REQUEST FOR INFORMATION **DATE:** May 16, 2016 **NO.:** RFI-083

Project Name: Webster University Interdisciplinary Science Building Project No.: 15051

Subject: Curtain wall structural clarifications

A0456

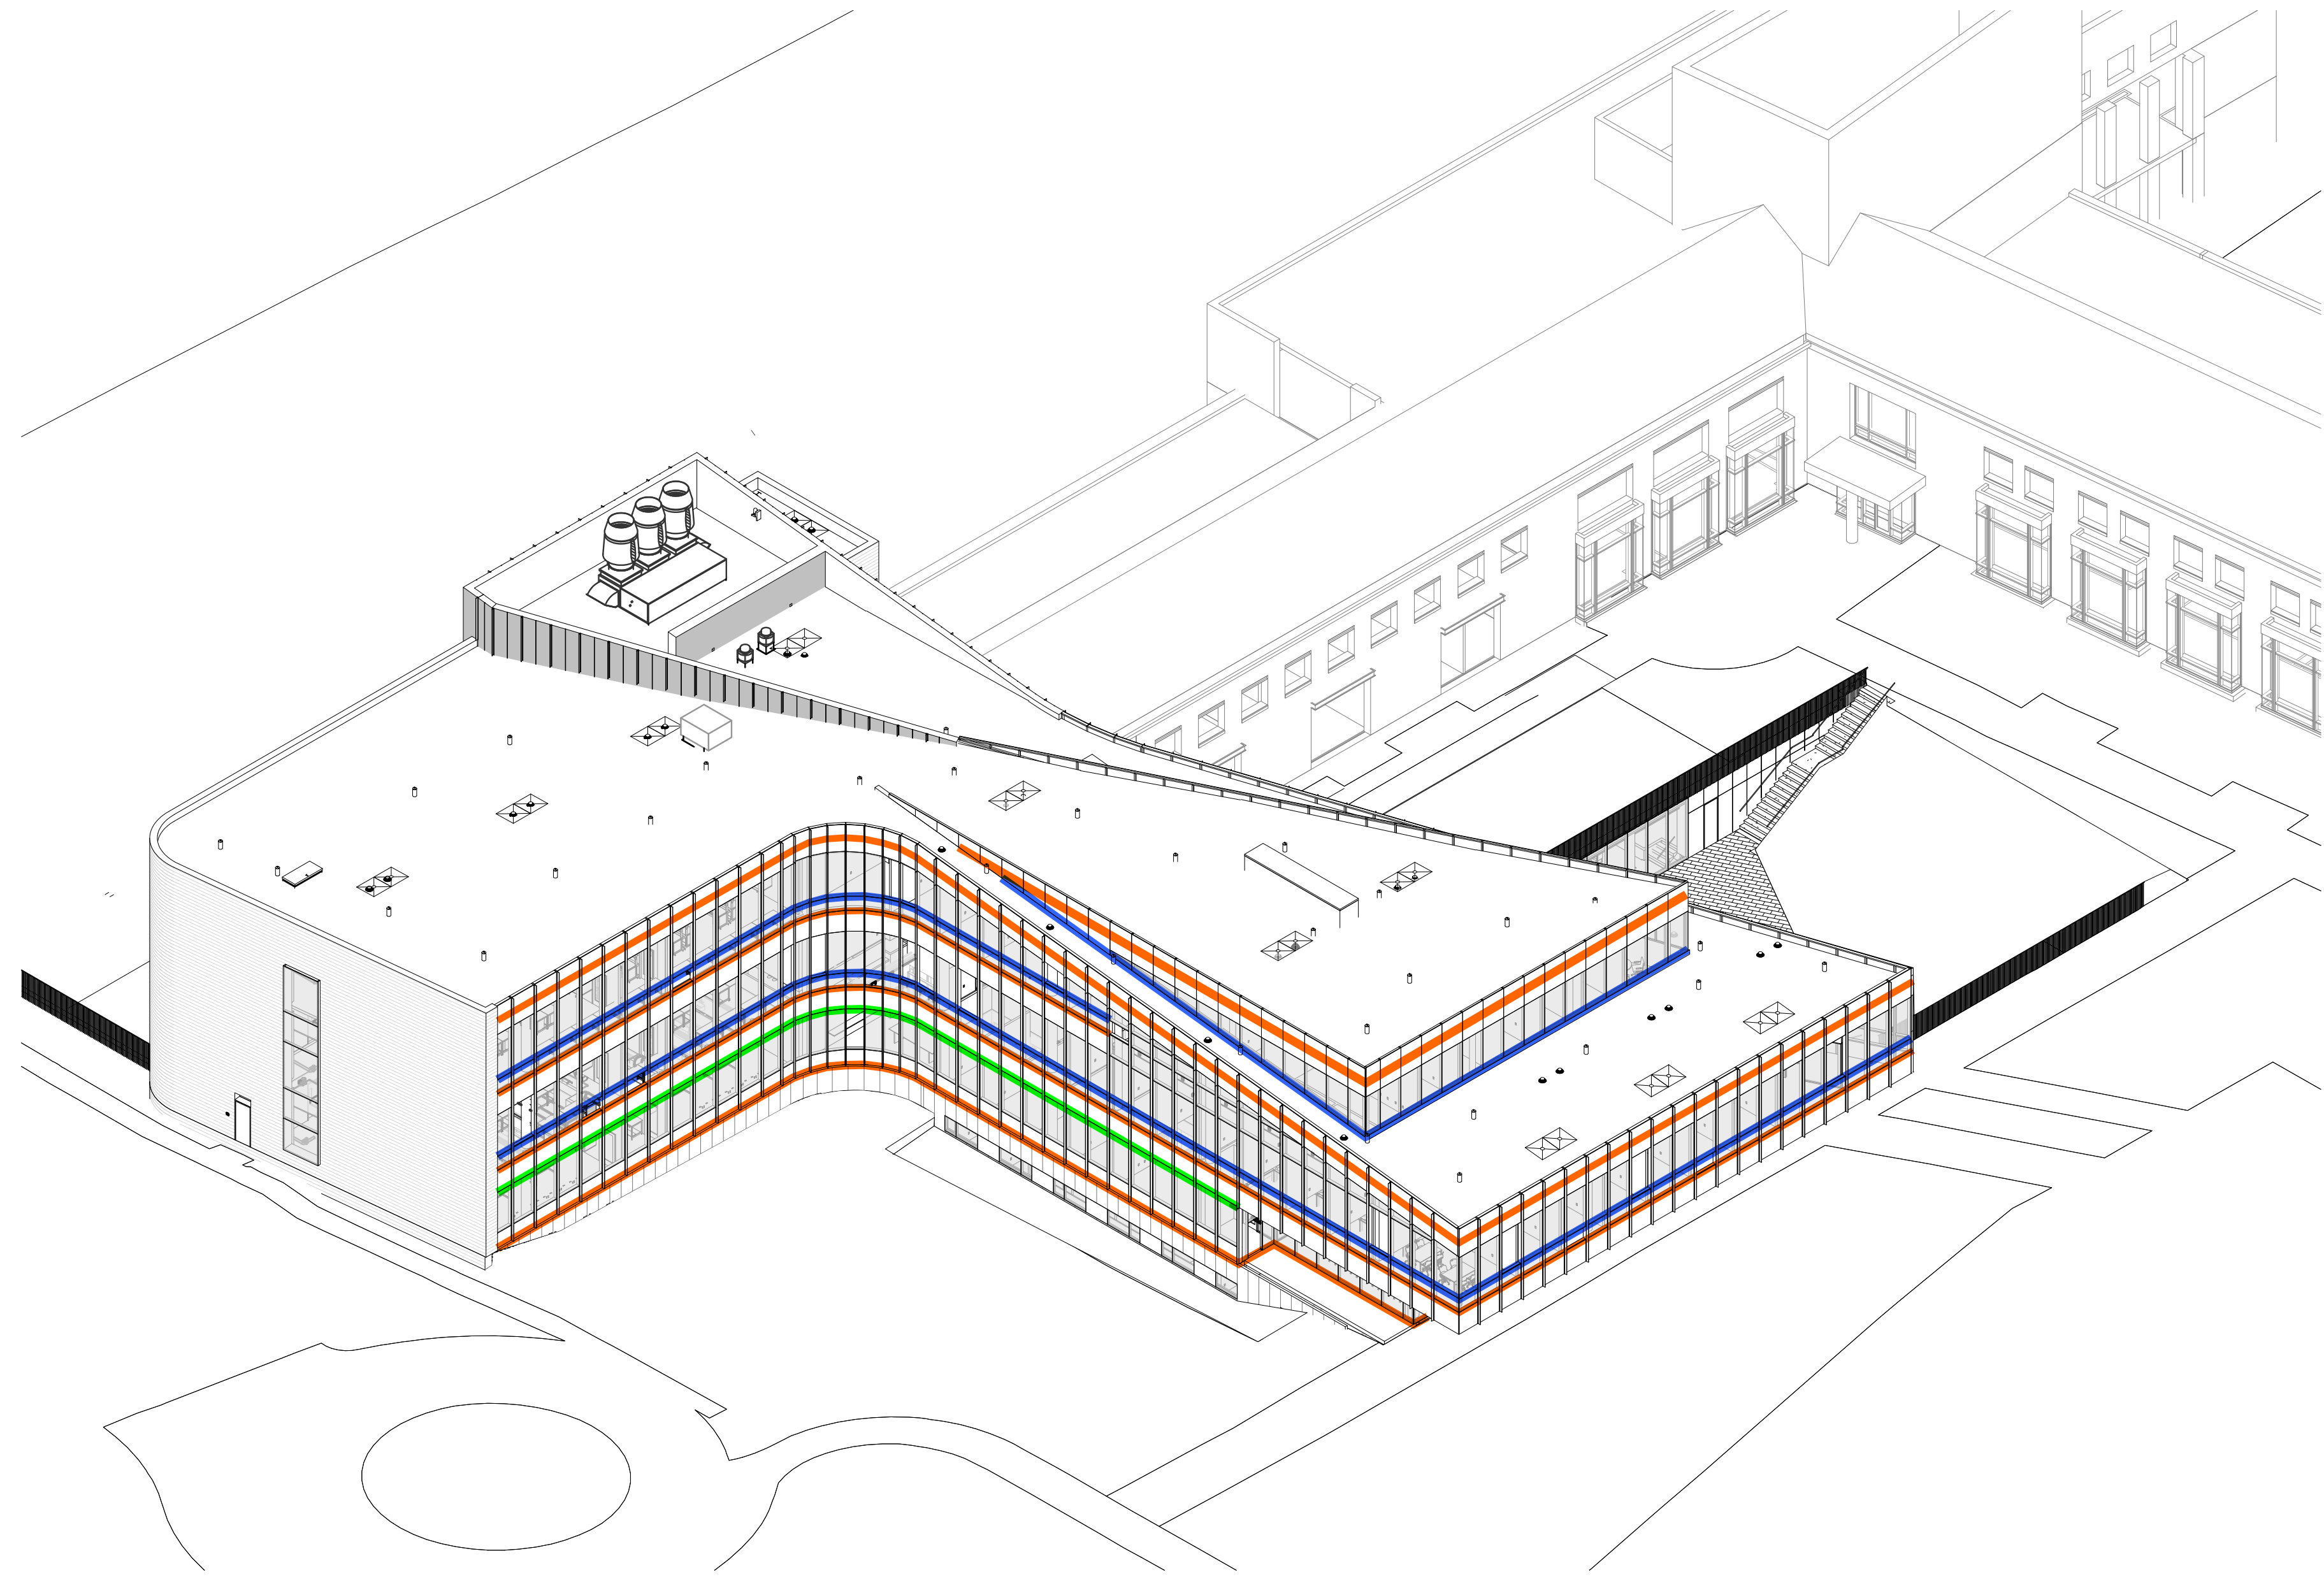
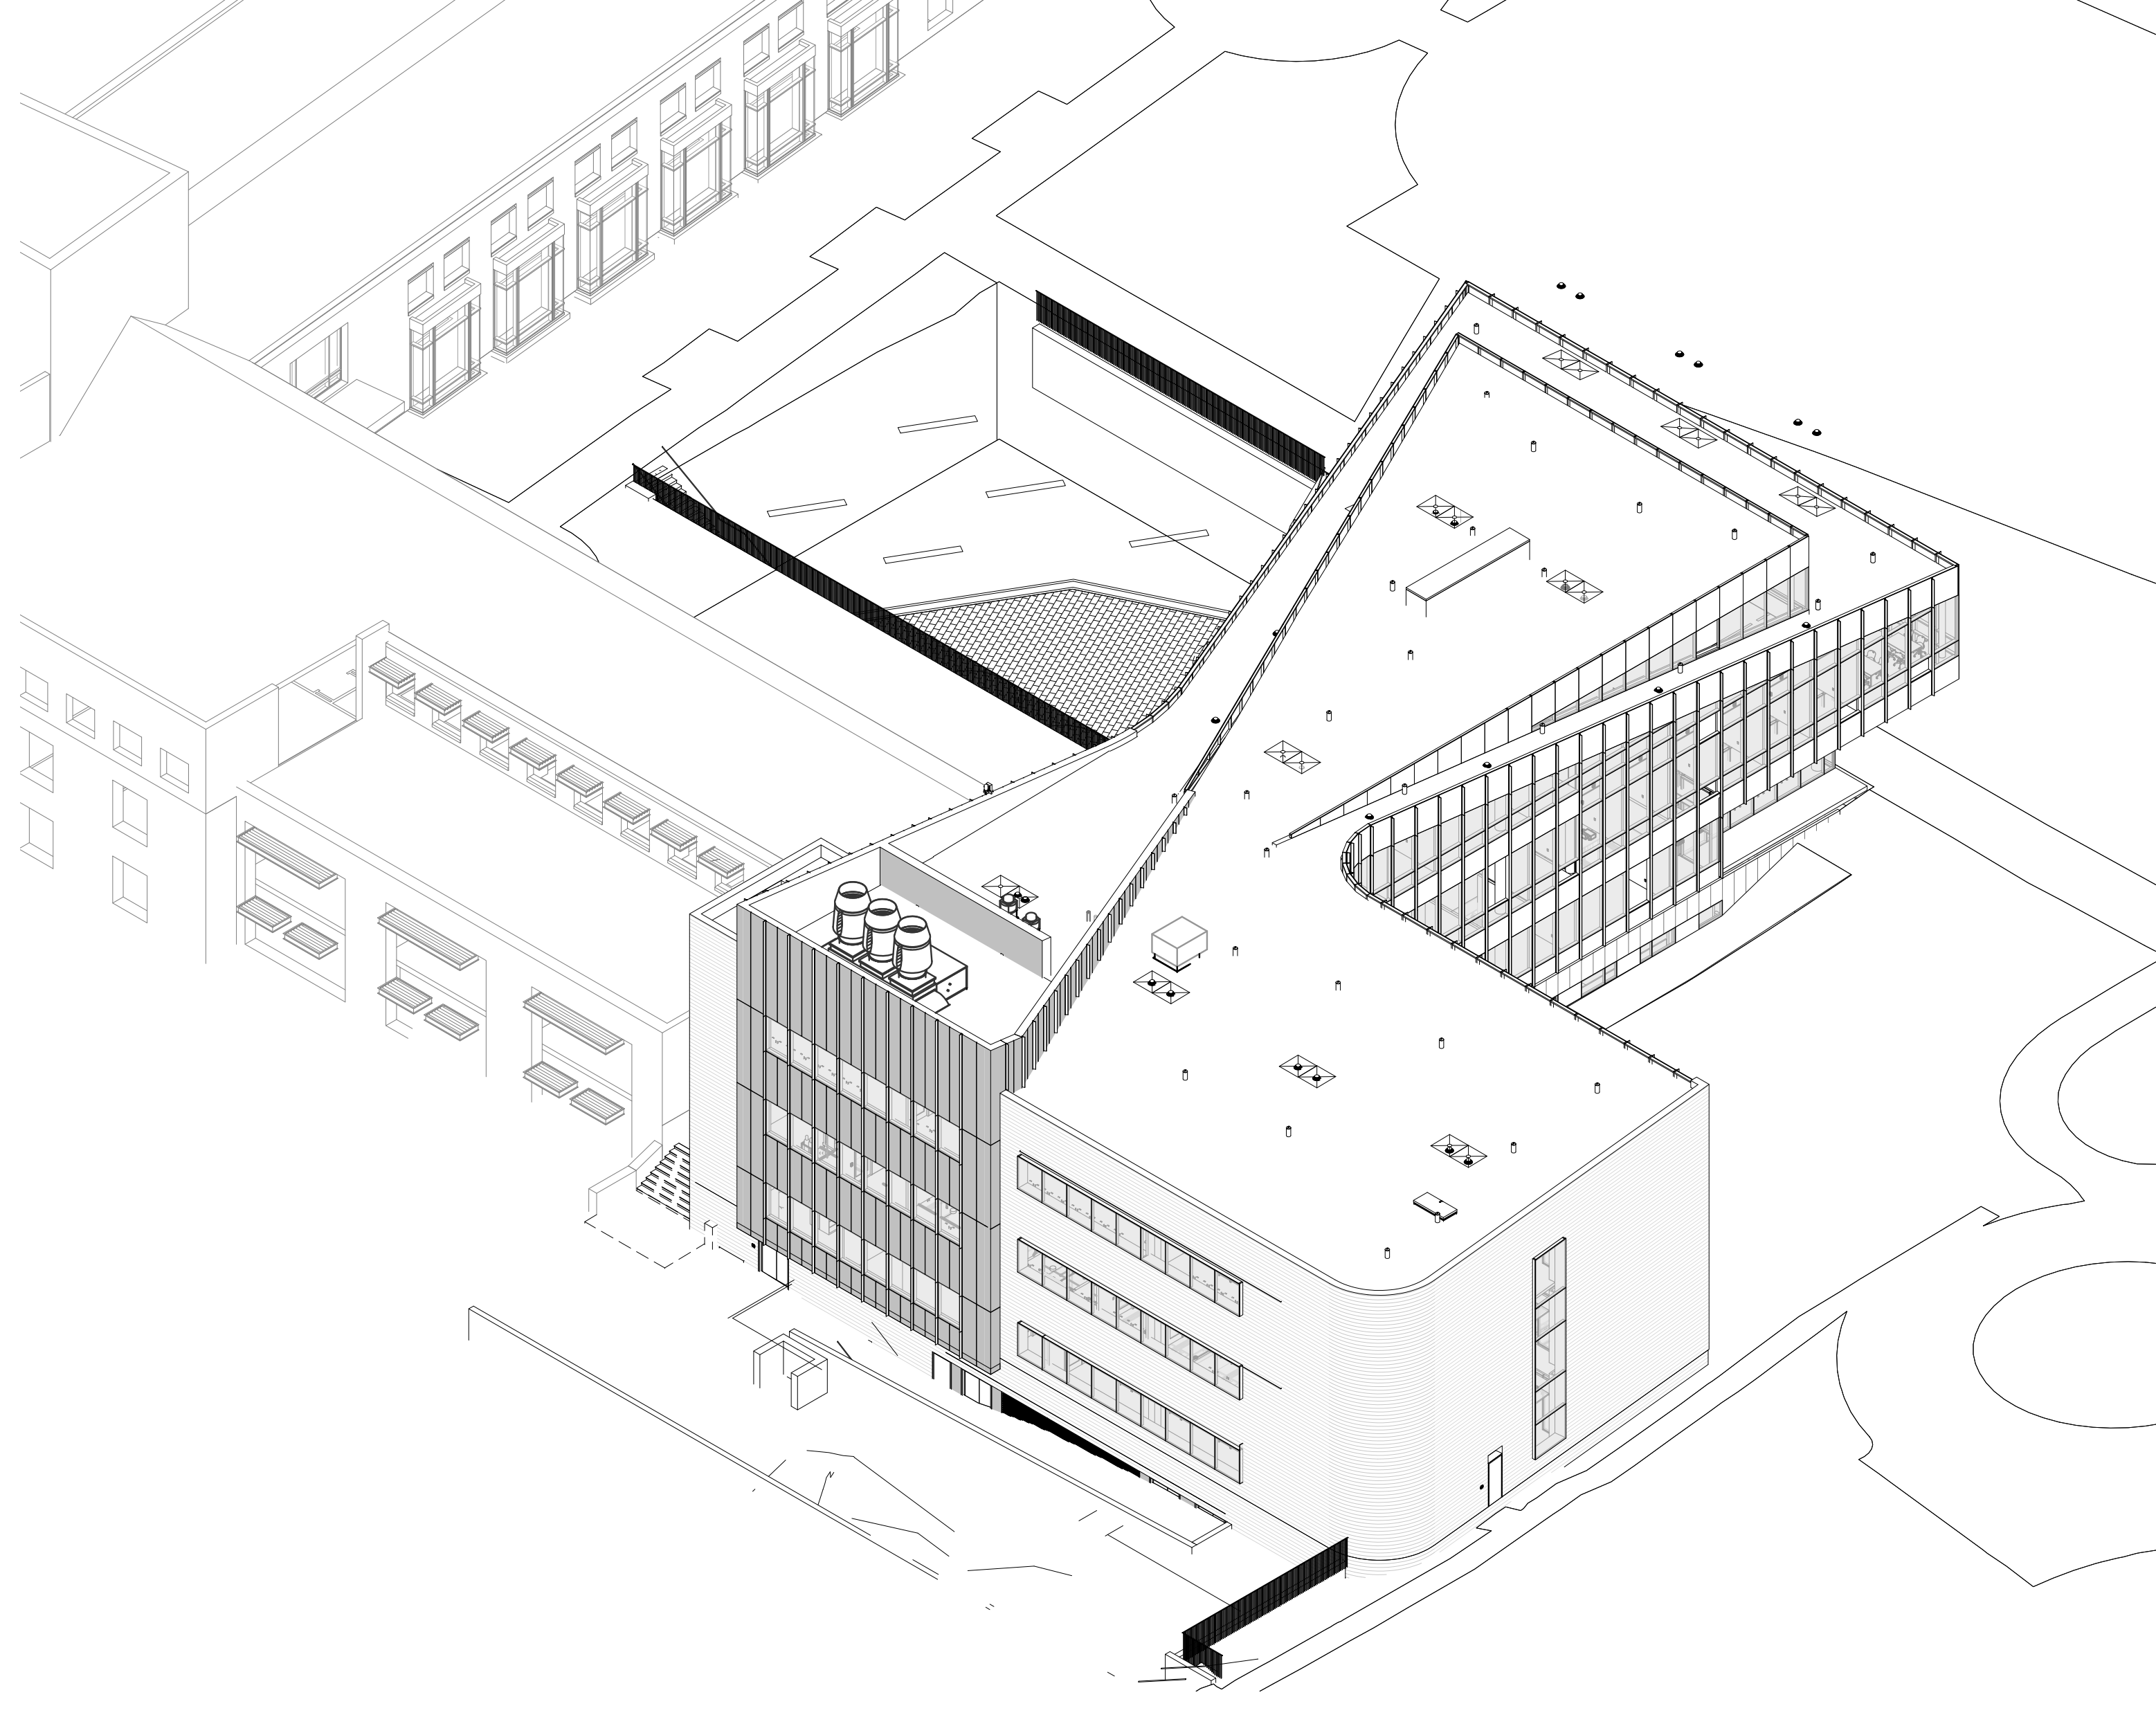
IS VERTICAL JOINT REQUIRED HERE, EACH SIDE, IF HUNG AT THE PROPOSED RED LINES?

Due to stack joint locations, 4th floor not supported as currently drawn.

Differential movement concerns with supporting the weight of these two portions at different floor lines.

6/A0452, 5/A0456 shows wind load connection. Weight of curtain wall not supported.

The stack joint is currently shown above the lateral load connection point, which is not possible, without anchor above it.

Red lines denote location where system weight would be supported

IF ADDITIONAL WALL WEIGHT IS PROPOSED FOR THE ROOF BEAMS, A DESIGN REVIEW AND POTENTIAL ROOF BEAM REVISIONS MAY BE REQ'D
